# UNITED STATES PATENT AND TRADEMARK OFFICE

APPLICATION NO.	FILING DATE	FIRST NAMED INVENTOR	ATTORNEY DOCKET NO.	CONFIRMATION NO.
10/083,606	02/27/2002	Koudai Yoshizawa	50340-112	7396

<b>Office Action Summary</b>	<b>Application No.</b> 10/083,606	<b>Applicant(s)</b> YOSHIZAWA ET AL.	
	<b>Examiner</b> Raymond Alejandro	<b>Art Unit</b> 1745

## **DETAILED ACTION**

FIG. 3a

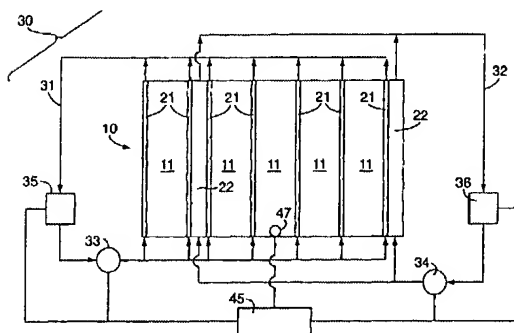
**Figure 3** below shows the fuel cell stack 10, a primary thermal management loop having a cool flow channel in thermal communication with the fuel cell and circulating a coolant; a secondary thermal management loop circulating an antifreeze flow channel spaced along the fuel cell stack; a heat exchanger in thermal communication with the secondary management loop; a thermal management loop controller which regulates said heat exchanger as to maintain said temperature above 32°F (CLAIM 9).

It is disclosed that the present invention provides for a dual thermal management loop apparatus having two thermal management loops (COL 9, line 65 to COL 10, line 7). It is further disclosed that the controller 45 controls both the primary and secondary thermal management loops according to a predetermined set of parameters to effect water management as well as ensuring that the fuel cell is not overheated (COL 8, lines 20-30); the controller also regulates the heat exchanger and pump by accepting temperature data from a temperature sensor to ensure that the fuel cell stack does not fall below freezing or alternatively, may be activated at a time after the fuel cell stack has fallen below freezing to quickly bring the fuel cell up above freezing (COL 8, lines 30-41). *Thus, these thermal management loops act as the protection devices for*
